Re: Initial Submission Review – Cherry Creek Elementary School #45 - Advisory Site Plan
Application Number: **DA-1617-16**
Case Number: **2021-6002-00**

Initial Submission Review

1 Sample Site Plan Cover Sheet

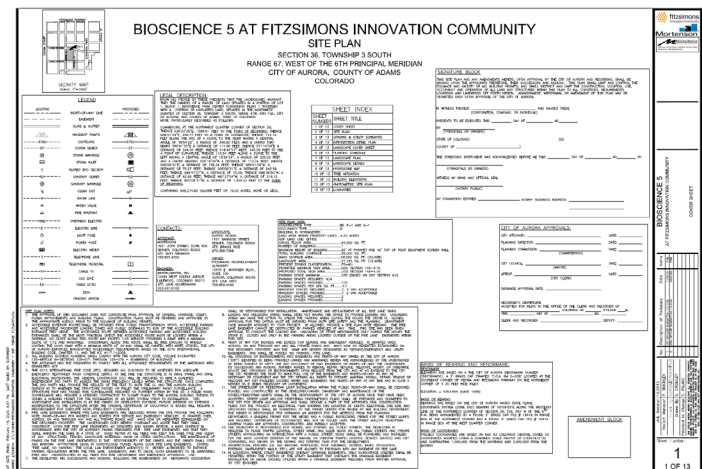
2A. Please reference the site plan shown in the graphic provided here for guidance on how to generally format the cover sheet of the site plan.
